CITY PLANNING COMMISSION

- APPLICATION:
1. Environmental Determination
 2. Amendment of Airport Community Plan from Light Density Residential to Multi-family Residential
 3. Rezone .31 vacant acres from Single Family (R-1) zone to Light Density Multi-family (R-3) zone

LOCATION: 2601-47th Avenue

PROPOSAL: The applicant is requesting the necessary entitlements to develop an eight-unit, two-story apartment building.

site plan

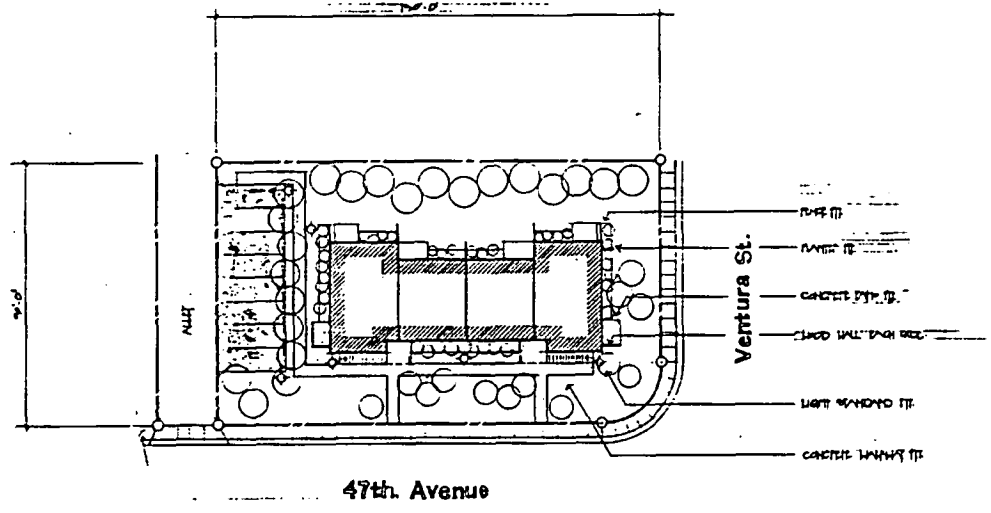
2. The site plan is not adequate for determining if the parking lot meets the required shading. The applicant has not indicated whether the parking will be covered or if the shading is to be achieved through landscaping. The landscaped planter adjacent to the parking lot is not wide enough to accommodate shade trees. The City requires a minimum six-foot of planter area for this purpose. The site plan also shows this planter area as part of the auto overhang which would only be allowed if the minimum width of the planter is six feet.

4. The applicant has indicated that the parking lot entrance is to be gained from a public alley, which is located between the two parcels proposed for apartment development. At the present time, the alley is unimproved and it will be necessary for the applicant to ensure the standard City improvements for this alley.

7. The required setback along 47th Avenue and Ventura Street is 25 feet. The site plans are not adequate to determine whether the required front setback has been met. The applicant will be required to submit revised site plans that indicate that the setback requirements have been satisfied. In addition, the site plan shows a large open area at the rear of the apartment structure. Staff believes this area would be better used by moving the structure farther to the north, which will provide more open space and landscaping along 47th Avenue.

- a. The applicant shall submit new site plans that indicate that required setbacks have been met;

- b. Landscape, shading and irrigation plans shall be submitted for staff review and approval;
- c. The applicant shall merge the two parcels;
- d. The project shall be subject to the review and approval of the Design Review/ Preservation Board;
- e. The applicant shall provide 50 percent shading of the parking lot area. All trees used for shading shall be located in a minimum six-foot planter as measured from the interior of the concrete curb;
- ** f. The applicant shall move the structure at least 10 feet to the north side of the site to provide more landscaped open space along 47th Avenue.
- g. *The applicant shall provide a 25-foot setback along Ventura Street.*

north & south elevation

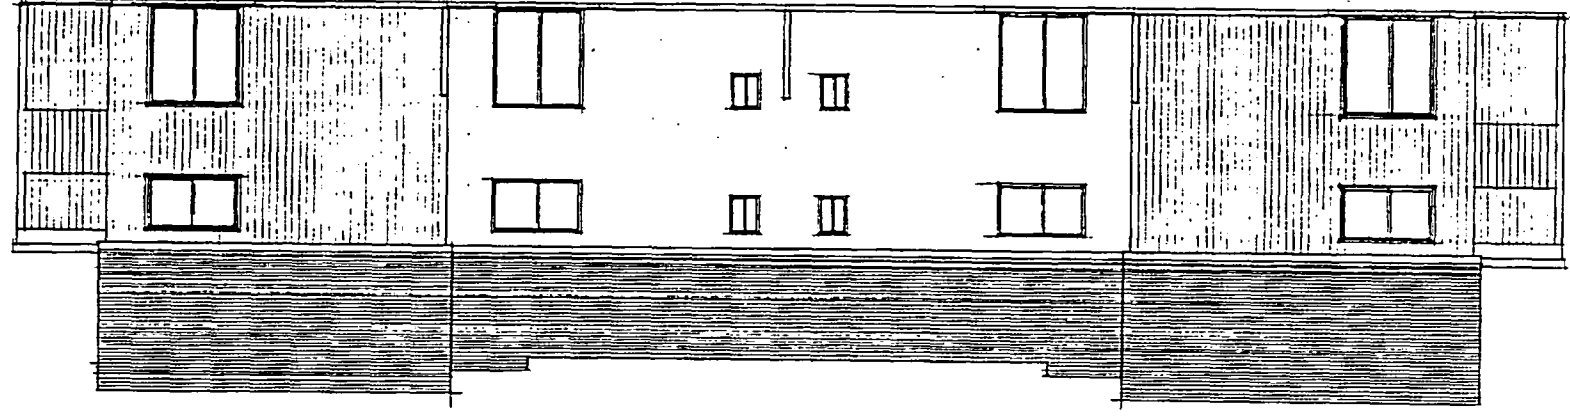
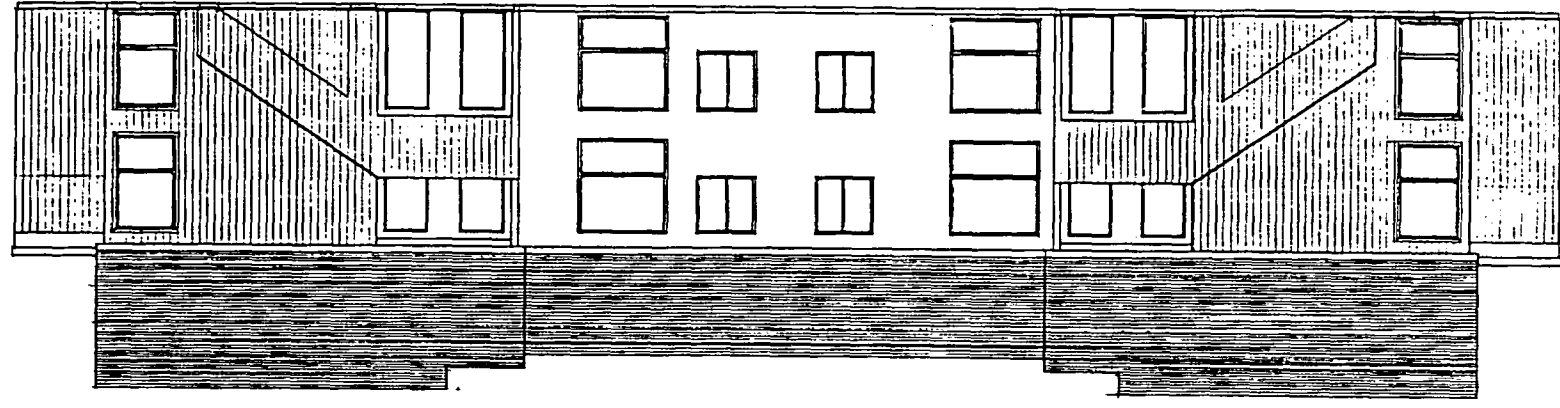
3. The elevations submitted with this request are unimaginative, and staff believes the design can be improved. In an effort to ensure the design quality of this project, staff recommends the elevations be subject to the Design Review/Preservation Board review and approval.
